D206-642-241
Job Sheet 171303

Part Name: Replacement Skidtube, High Gear with Standard Wearplates Fits LH or RH

DRAWING NO. D2650	TITLE 206/407 SKIDTUBE ASSEMBLIES	REV. F	DART AEROSPACE LTD ENGINEERING ORDER		D.E.O. NO. D2650-F-1	SHEET NO. SHEET 1 OF 1	SCALE NTS
DRAWN <i>[Signature]</i>	CHECKED A.P.	MFG. APPR. <i>[Signature]</i>	APPROVED <i>[Signature]</i>		DE APPR. <i>[Signature]</i>		
DATE 12.10.12	DATE 12.10.22	DATE 12.10.22	DATE 12.10.22		DATE 12.10.22

CHANGE C'BORED WELDED CROSSBOLT SPACERS TO SWAGED SPACERS

DETAIL G

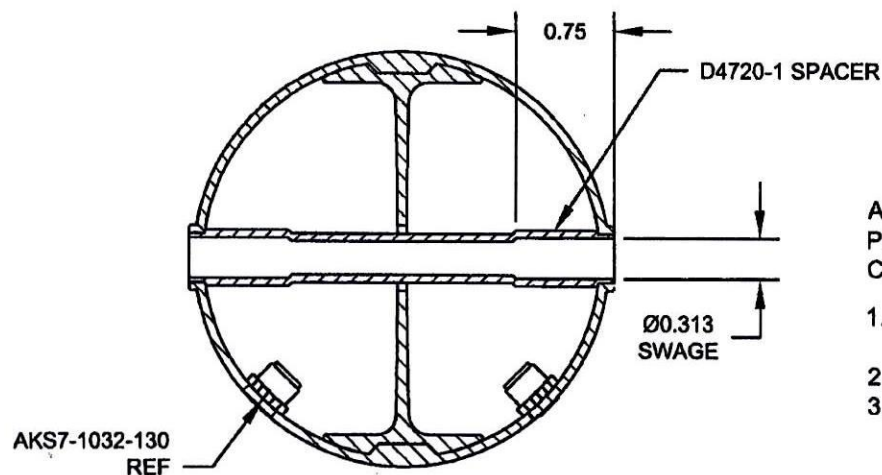
ADD DETAIL G BELOW, WHICH IS THE SAME SECTION VIEW AS DETAIL D OF DWG.

C'BORED HOLES ARE NOW SWAGED PER DETAIL G BELOW. FOR THE Ø0.375 HOLE THAT IS NOT C'BORED, WELD PER DETAIL D OF DWG (SEE AMENDED DETAIL B FOR REFERENCE).

AFTER DRILLING AND BENDING ASSEMBLY
PERFORM THE FOLLOWING FOR Ø0.375 HOLES THAT ARE
CURRENTLY C'BORED:

1. INSERT D4720-1 SPACER, 16 PL (-1) OR 17 PL (-3)
OR 19 PL (-5) OR 23 PL (-7)
2. SWAGE TO Ø0.313 X 0.75 DP PER QSI 002
3. TRIM / GRIND FLUSH PER QSI 002
